Subject: **Bid No. 8022-W3, Temporary Chiller Installation – WPD HQ / DPF**

ADDENDUM NO. 1

WORCESTER
POLICE
HEADQUARTERS
TEMP. CHILLER
REPLACEMENT

ROOF PLAN,
ROOF DETAIL &
CONTRACTOR STAGING/
LIFT AREA PARAMETERS

2 PROPOSED CONTRACTOR STAGING AND LIFT AREA PARAMETERS
SCALE: NTS

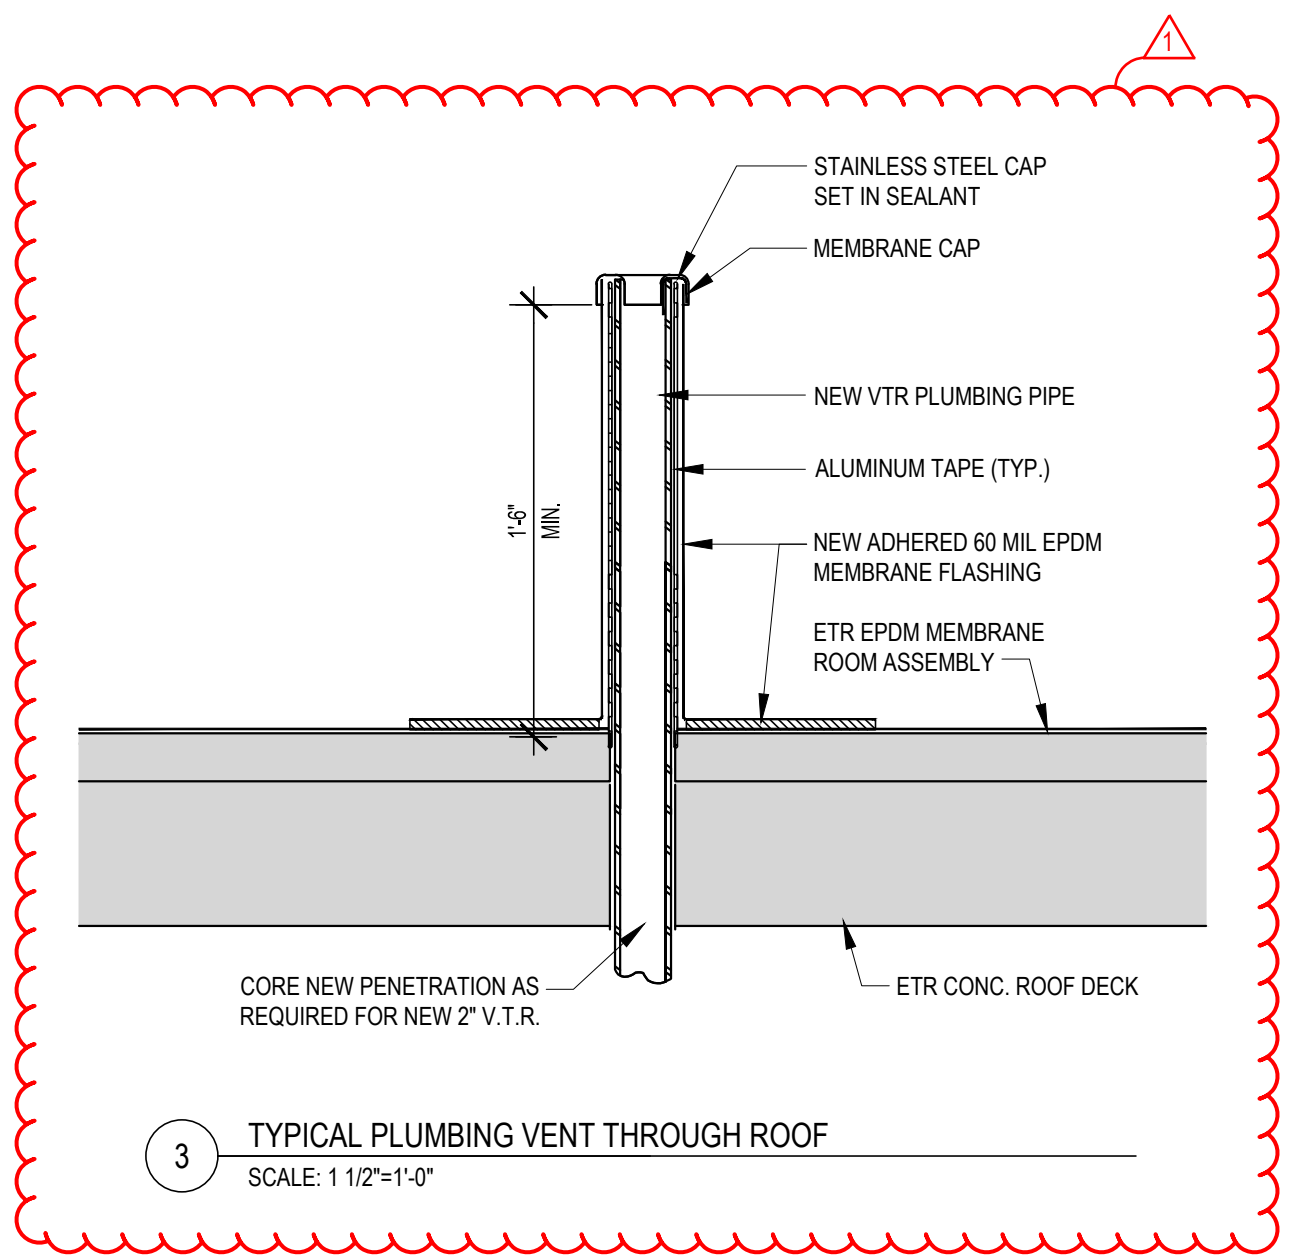
- **PLEASE FIND BELOW/ATTACHED GENERAL BID CLARIFICATIONS INCLUDING UPDATED DRAWING A2.01**
